CITY OF HOOD RIVER

Re: Recommendations for WACP Streets, Bicycle & Pedestrian Frameworks (File No. 2018-07)

Separated Bike Lane

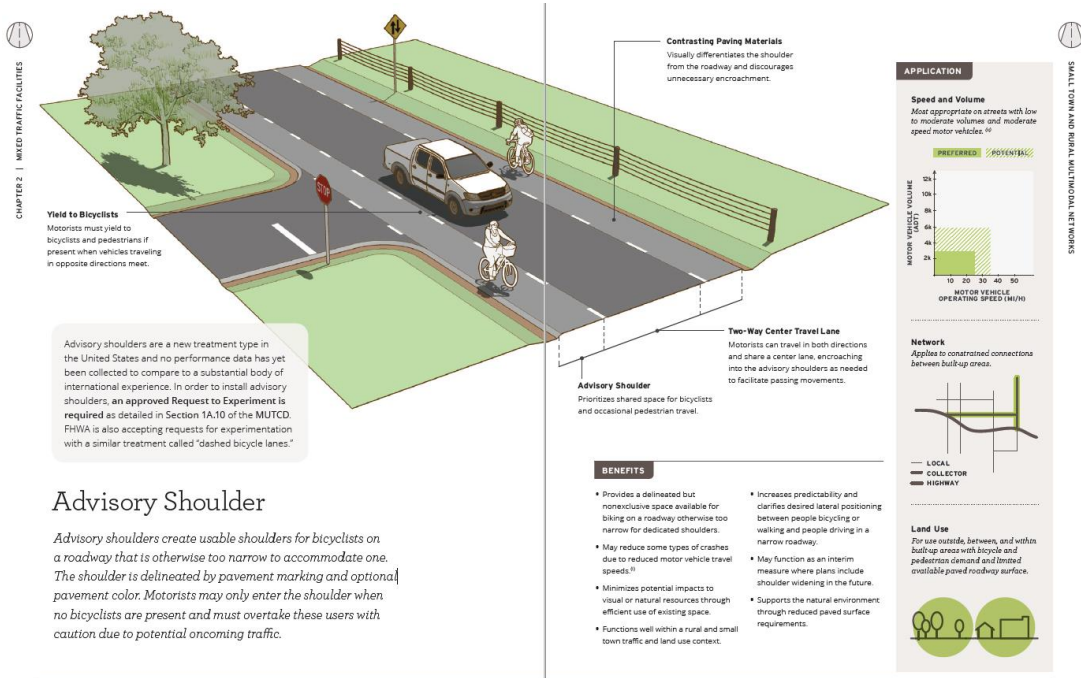
- Update the Transportation System project list to include identified projects into a funded status;
- Update the Motor Vehicle System Plan of the TSP to be consistent with the Streets Framework including the addition of intersection design alternatives at Mount Adams Ave. and Cascade Ave.;
- Update the proposed minor arterial cross-sections (specifically Alignment D of the Mt. Adams Extension) to replace the visually separated on street bike lane with a physically separated bike lane as depicted in the Federal Highway Administration's, "Small Town and Rural Multimodal Networks" publication (shown below). However, also consider maintenance requirements for physically separated bike lanes. The section is intended to be accommodating to recreation, novice, or younger users, and provides an additional buffer between vehicular and pedestrian travel modes.

As shown in the design below, the bicycle path returns the users back to the road at intersection locations.

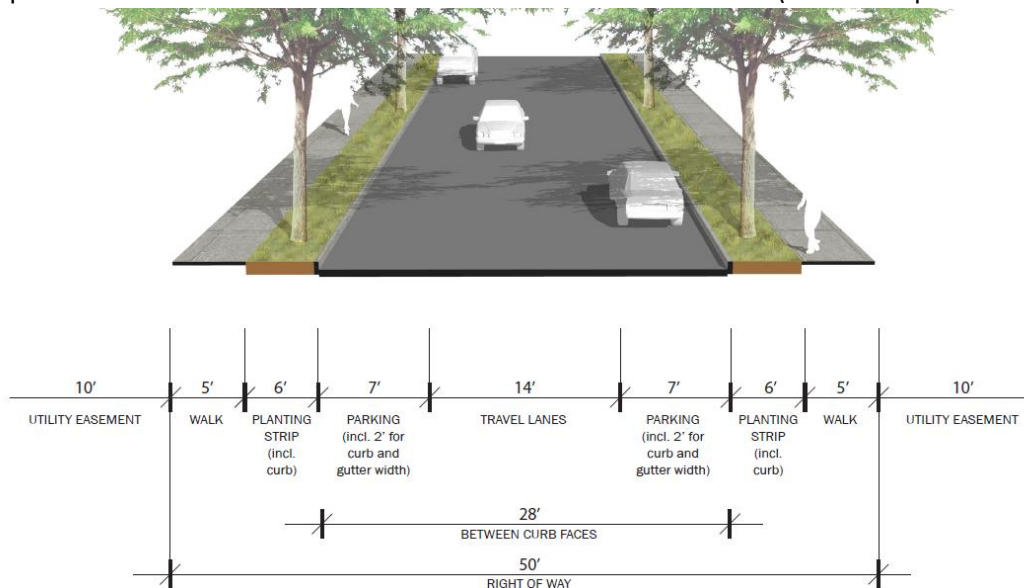
- The Commission recommends a modified cross section for Local Streets that separates sidewalks from streets with planter strips and street trees (see cross section below). The cross section includes a minimum 5-foot-wide sidewalk but planning Commission suggests 6-foot-wide sidewalks if pavement width can be narrowed from 28-foot- to 26-foot wide (retain 5.5’ planter strips).

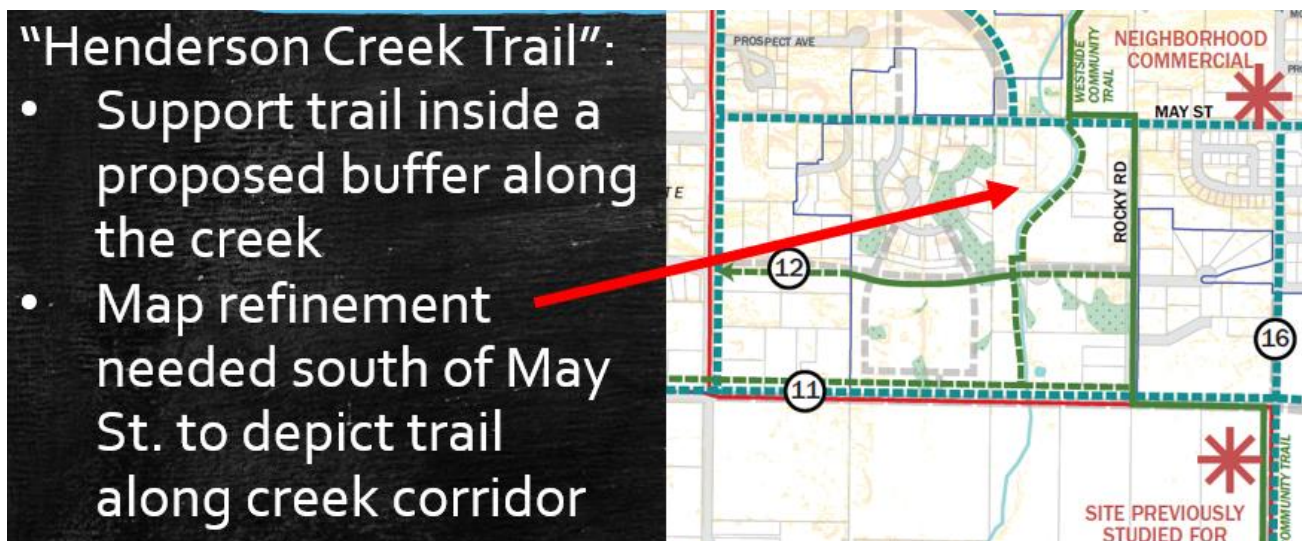
- Concern regarding “bikeability” of steep roads. Henderson Creek alignment may be preferable for for bikes due to gentler grade in most areas, but the Framework currently anticipates use of 6-foot-wide trail by pedestrians only rather than a multi-use path.

"Westside Community Trail":

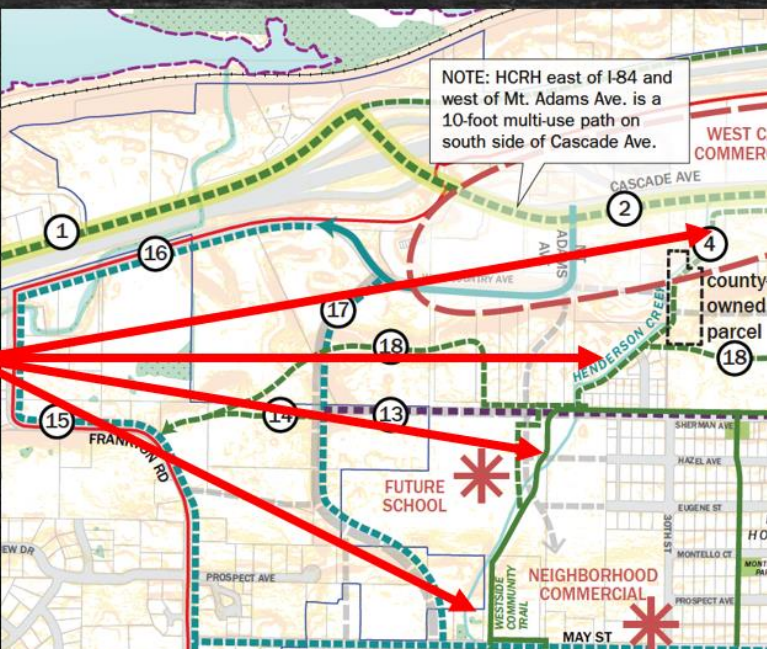
- The Commission recommends adding the Westside Community Trail to Pedestrian and Bicycle Framework map immediately north of May St., tying into the Henderson Creek Trail on the school district's property.

- Along Rocky Rd., pedestrians should not be on street.
- Retain existing segment immediately north of May St.

“Westside Community Trail”:

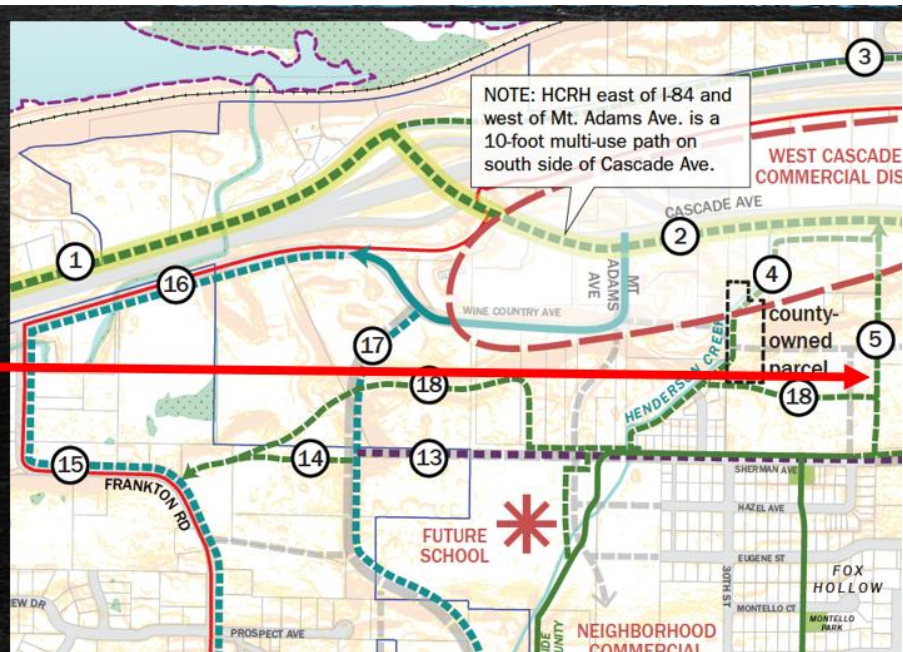
- The Commission recommends changing the location of Westside Community Trail east of Frankton Road (portion of Trail 12) to align with Carr Dr. rather than Blackberry Dr. due to nature of existing road easements.

- Trail Segment 12 off of Frankton Rd. should be via Carr Drive rather than Blackberry Dr., through Willow Ponds to Rocky Rd.

**Trail Segment 10
(10' off-street asphalt or concrete path):**

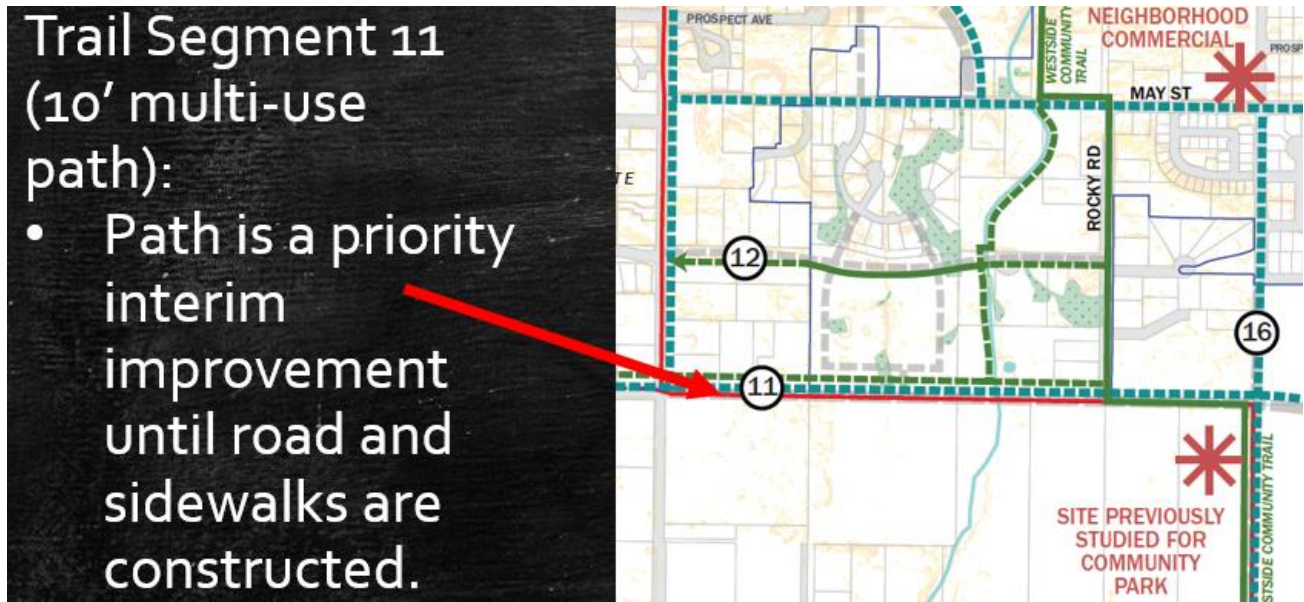
- The Commission recommends a portion of the Upper Terrace Neighborhood path (Path 10) is not constructed adjacent to a future Connector Street between May St. and Post Canyon Dr. (however, retain trail segment between Post Canyon Dr. and Belmont Dr.).

- Not needed parallel to future Neighborhood Connector street with sidewalks
